OCONEE NUCLEAR STATION, UNIT 1

AMENDMENT TO FACILITY OPERATING LICENSE

ATTACHMENT TO LICENSE AMENDMENTS

OCONEE NUCLEAR STATION, UNITS 1, 2, AND 3

FIGURE 6.1-1 | 14/9/1

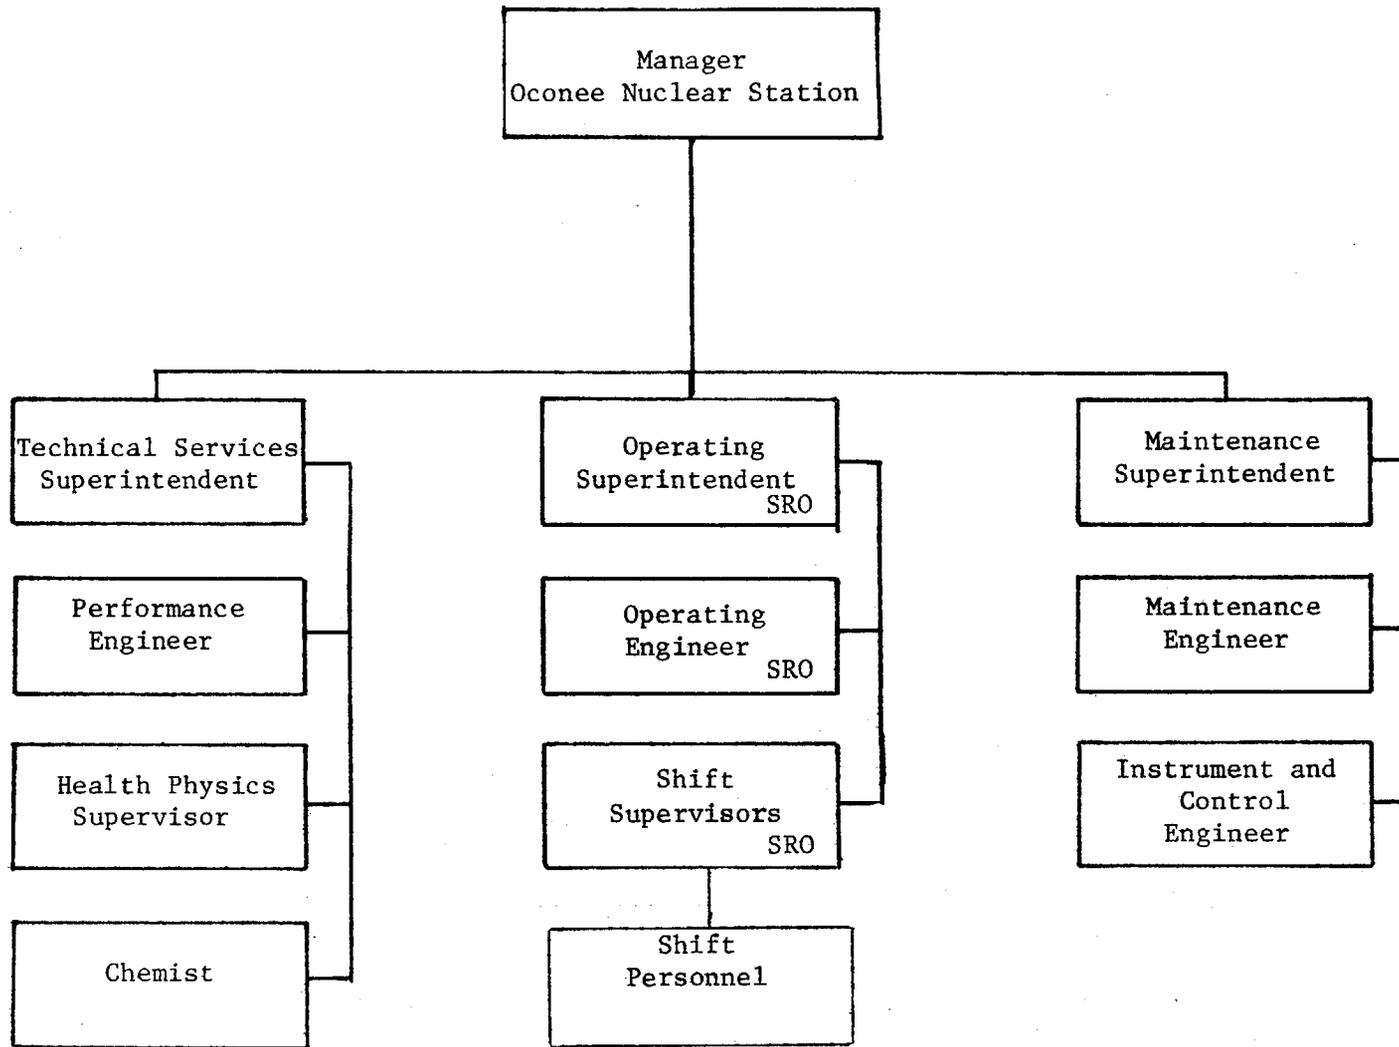
The following changes to the station organization chart have been proposed:

1. The title of Plant Superintendent will be changed to Station Manager.
2. The position of Assistant Plant Superintendent will be eliminated.
3. Clerical Staff and Visitor Center Staff will be removed from the chart.
4. The supervisor's titles in the two service groups and the operating group will be changed from Engineer to Superintendent.

OCONEE NUCLEAR STATION
MANAGEMENT ORGANIZATION CHART
FIGURE 6.1-2 | 14/9/1

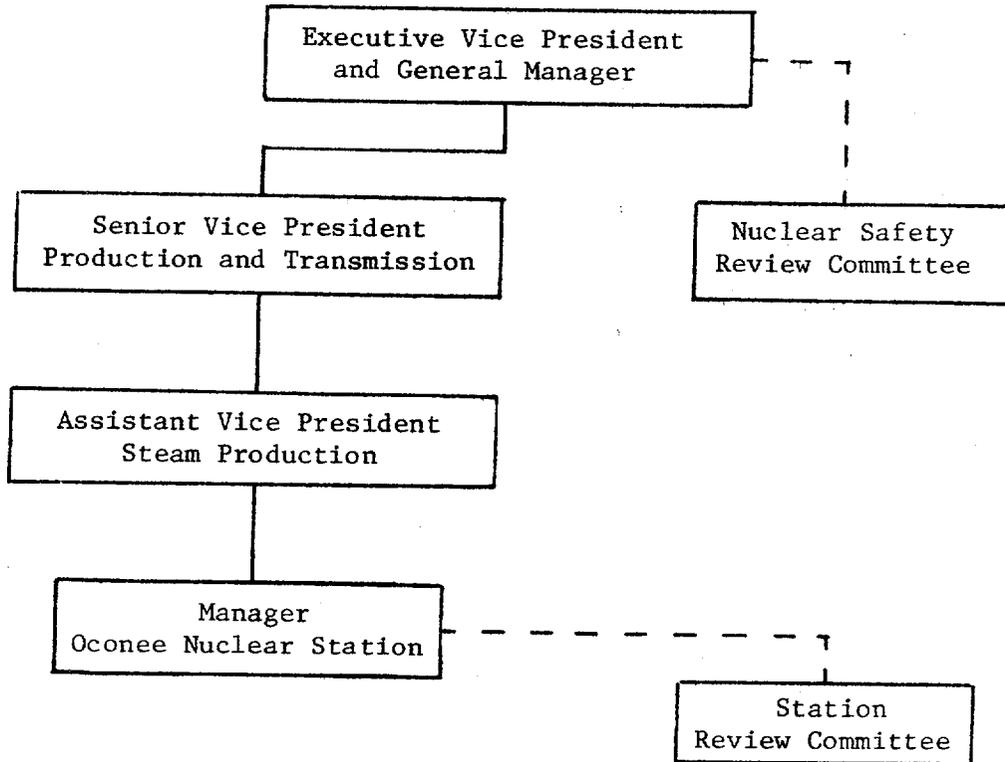
The proposed change in the management organization chart (Figure 6.1-2) will simplify the reporting channels for the Safety Review Committee and the Station Review Committee.
